<b>Panel Reference</b>	PPSSNH-367
<b>DA Number</b>	DA0049/23
<b>LGA</b>	Ku-ring-gai
<b>Proposed Development</b>	Demolish existing structures (including Roseville RSL Club and retail tenancy) and construct a mixed-use building comprising new ground floor RSL Club, signage, shop-top housing of 37 residential dwellings, basement parking, associated works and subdivision.
<b>Street Address</b>	62-66 Pacific Highway, Roseville
<b>Applicant/Owner</b>	Applicant: Hyecorp  Owner's: Roseville Returned Servicemen's Memorial Club Limited & Ku-ring-gai Council.
<b>Date of DA lodgement</b>	13 February 2023
<b>Total number of Submissions Number of Unique Objections</b>	Four
<b>Recommendation</b>	Approval: Deferred Commencement
<b>Regional Development Criteria Schedule 7 of the SEPP (Planning Systems) 2021</b>	General development that has a capital investment value of more than \$30 million & Works on land to which Council has an interest in excess of \$5 million.

<b>Report prepared by</b>	Andrew Martin
<b>Report date</b>	15/11/2023

To determine Development Application No. DA0049/23 to demolish existing structures (including Roseville RSL Club and retail tenancy) and construct a mixed-use buildi

**Figure 7: Notation to be amended**

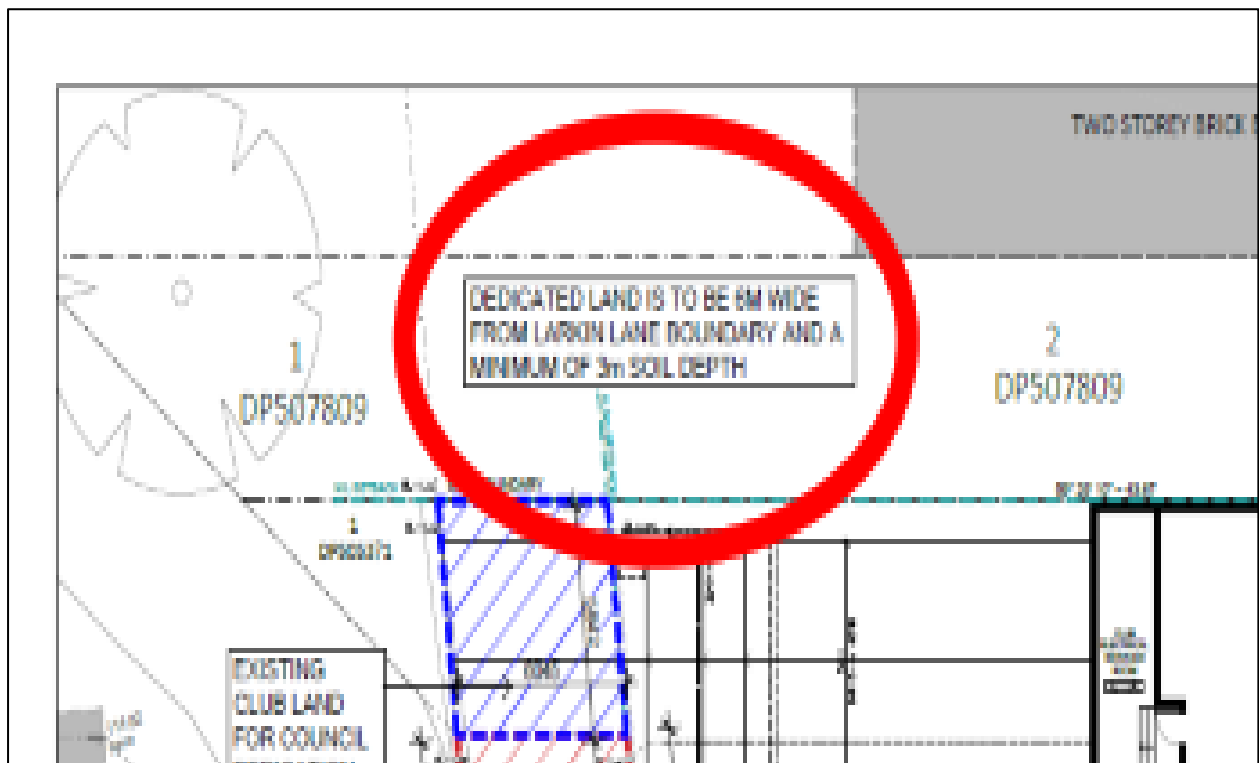
*The proposal generally appears to have complied with the requirements regarding the land dedication subject of a separate Planning Agreement; however, **one further clarification annotation** is required to the floor plan below.*

*Amend the circled annotation at the top of the drawing to add additional text shown in red below:*

- *from - dedicated land is to be 6m wide from larkin lane boundary and a minimum of 3m soil depth.*
- *to - dedicated land is to be 6m wide from larkin lane boundary and a minimum of 3m soil depth for the total length of the development site (64-66 pacific hwy) fronting larkin lane.*

The plans have been updated to reflect the notation requirements in the referral and, accordingly, no additional condition is required.
